Kresge College Renewal and Expansion Project

Final Environmental Impact Report
SCH#2018042015

3 Response to Comments

Figure 2-10 Summary of Building Demolition, Construction, and Renovation

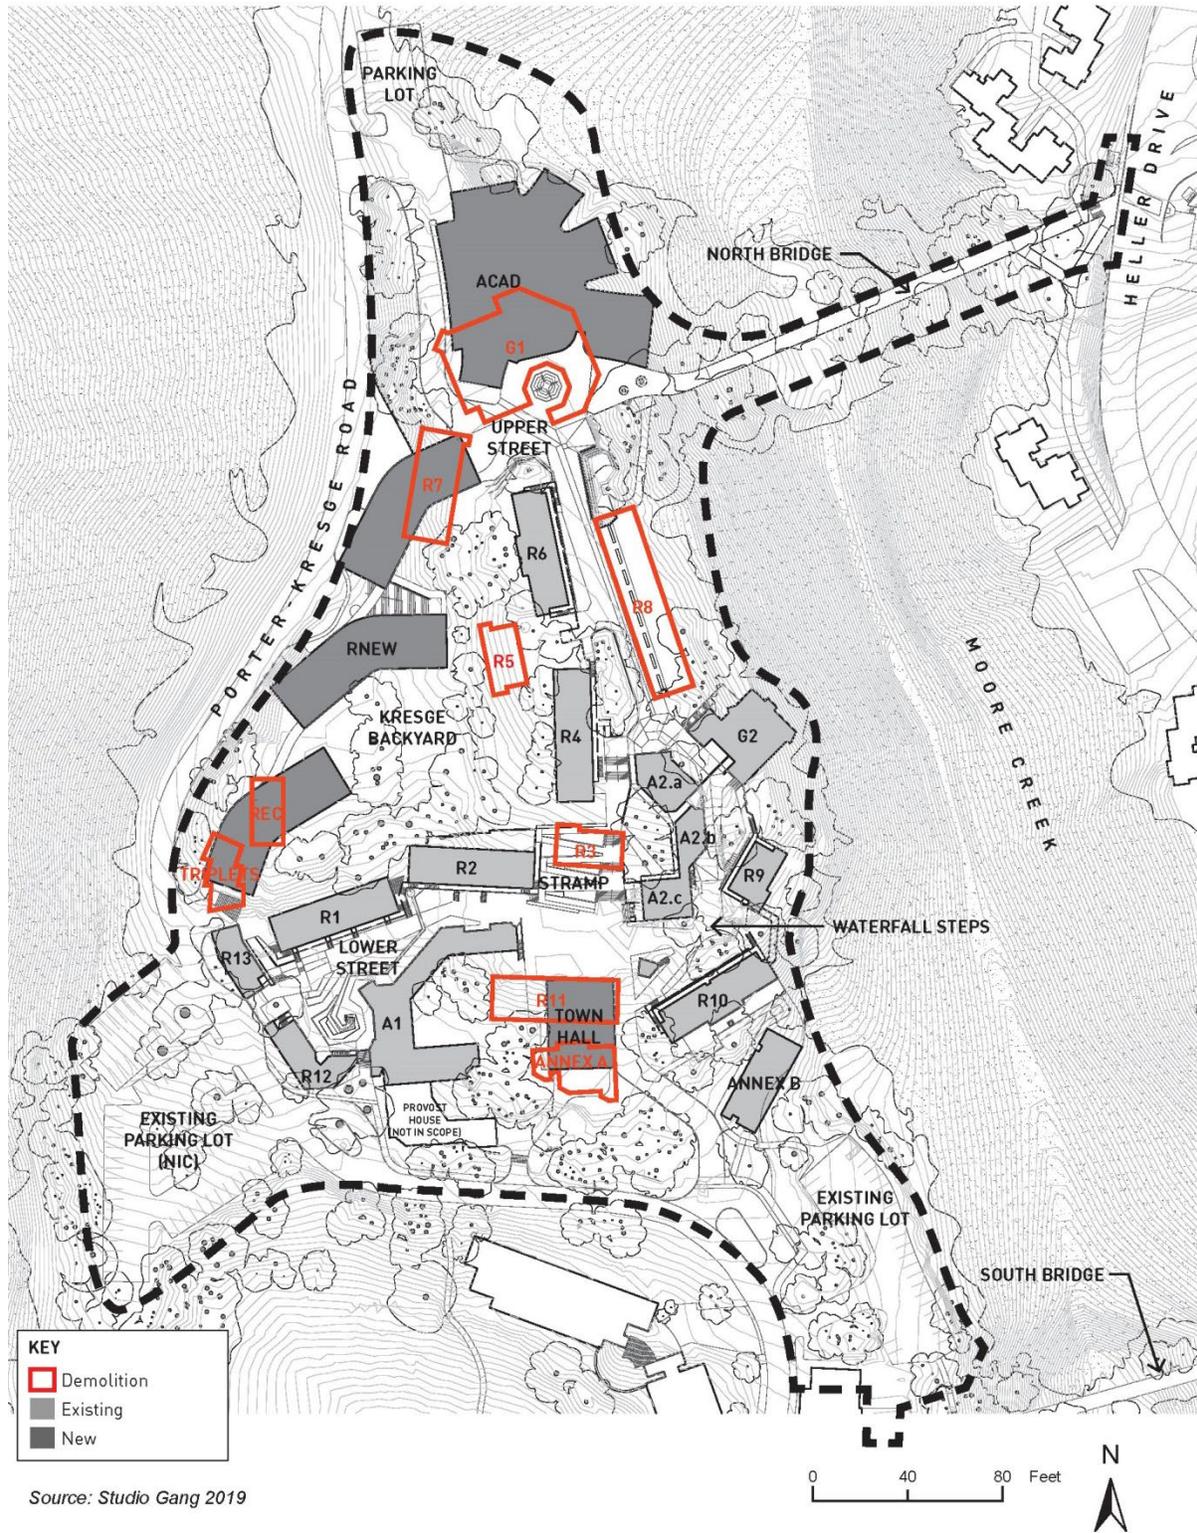
Since release of the Draft EIR, design refinements have resulted in slight modifications to the proposed project. These changes include the following:

The new ACAD building would replace office and classroom spaces in buildings that would be demolished or redeveloped as non-academic space. As shown in Figure 2-10 and Table 2-2, the project would demolish one ~~two~~ existing academic buildings (Annex A ~~and Annex B~~) and would convert buildings A1, ~~and A2,~~ and Annex B to residential, ~~and~~ student support service, and maintenance workshop uses, respectively. These existing buildings would no longer be used as academic space. Therefore, the project would eliminate all existing 363 general assignment classroom seats at Kresge College.

Figure 2-19 Proposed Circulation and Access

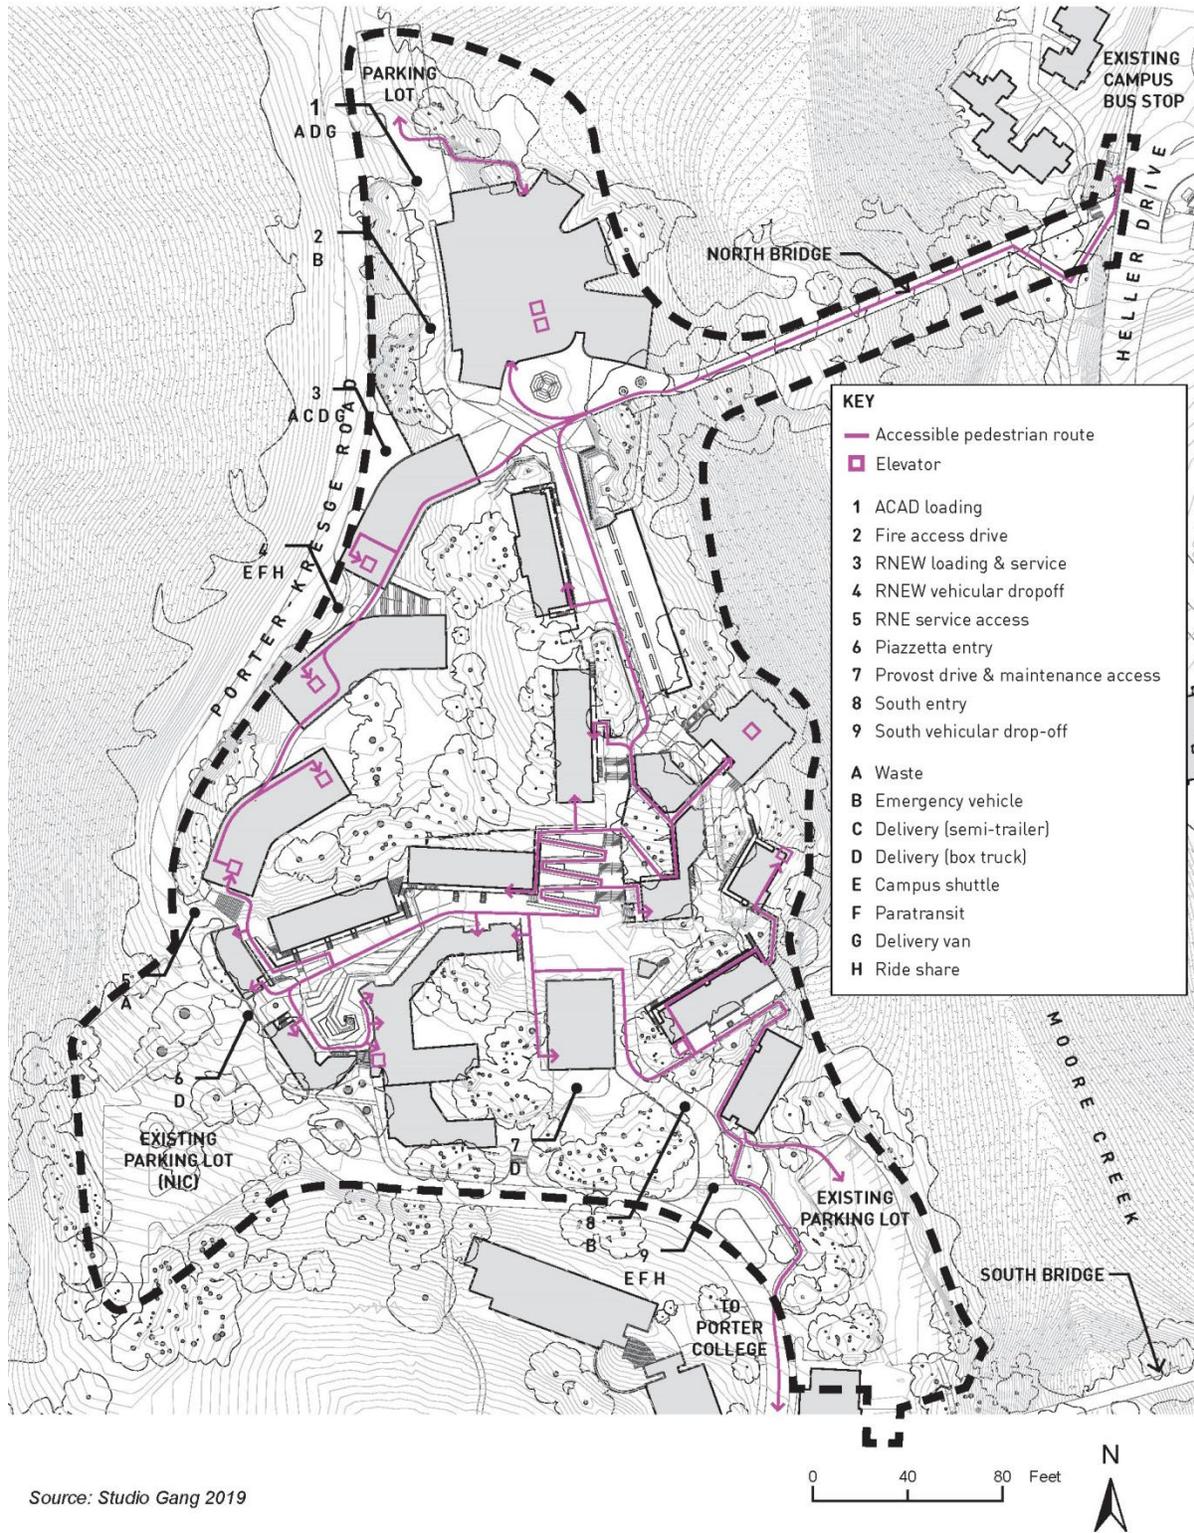
- b. Bicycle and pedestrian paths should be wide enough and strong enough to support emergency vehicles. Currently there are a number of paths that do not support Emergency Vehicle Access (EVA) and significantly delays emergency response.

- c. Provide for Emergency Vehicle Access (EVA) to all new and renovated buildings. Allow adequate approach and egress routes as determined by the Fire Marshal.

The project would comply with the California Fire Code, and the project plans provide adequate emergency vehicle access to buildings, including a new emergency vehicle access drive at the south end of the site, as shown in Figure 2-19 in Section 2.0, *Project Description*. In addition, the project would comply with the International Uniform Wildland Interface Code, which establishes regulations for land use and the built environment in designated wildland-urban interface areas using prescriptive and performance- related provisions. Refer to Section 4.9, *Hazards and Hazardous Materials*, for discussion of fire hazards.

Figure 2-21 Proposed Stormwater Management System

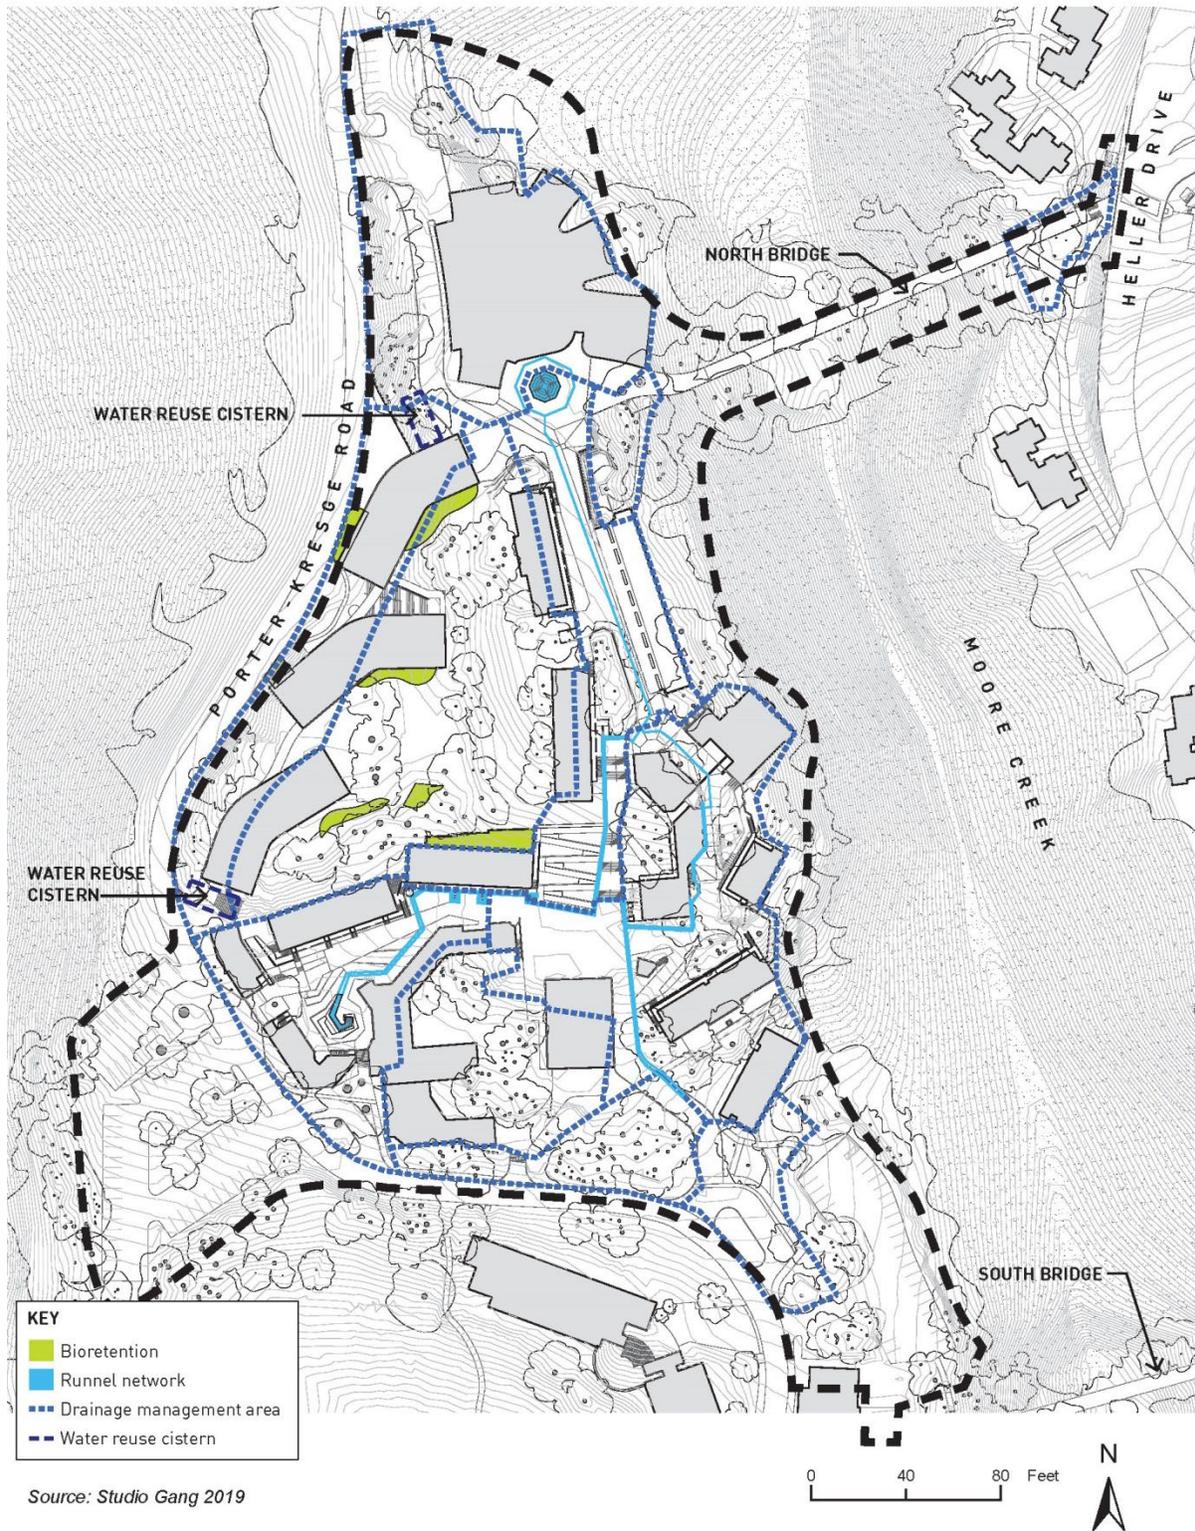
- Two sub-surface stormwater retention tanks would be installed, instead of a retention tank and a reuse tank, and the locations of the tanks would change to accommodate retaining the Annex B building

The proposed stormwater management system, shown in Figure 2-21, involves natural features in the Backyard to promote infiltration and more urban solutions including surface runnels and sub-surface pipes through the rest of the site. The system would include bioretention, two sub-surface retention tanks ~~(a retention tank and a reuse tank)~~ that would provide for storage of captured stormwater, a treatment room including a blending tank that would treat and reuse ~~of~~ captured stormwater, and re-use of existing surface runnels (i.e., narrow channels in the ground through which liquid can flow) and sub-surface pipes for water conveyance. Most stormwater would be conveyed to the two sub-surface stormwater harvesting tanks. In addition, dispersed bio-swale locations around the site ~~Backyard~~ would capture and treat ~~filter~~ some stormwater before infiltrating into native soils ~~discharge to this tank~~. In hardscaped areas of the complex, surface runnels and sub-surface pipes would convey ~~channel~~ stormwater to the Backyard, bio-retention rain gardens, bio-swales, and/or the retention tanks. A new stormwater harvesting tank would be installed south of the southernmost RNEW building and another at the ACAD plaza ~~beneath the pathways south of R10~~. Water would be pumped from these ~~this~~ tanks to a new water treatment room ~~reuse tank~~ located north of the northernmost RNEW building, west of the proposed ACAD building ~~beneath the proposed pavilion where the R8 building is currently located~~. The reuse system ~~tank~~ would supply water to the College's purple pipe (i.e., non-potable water) network.
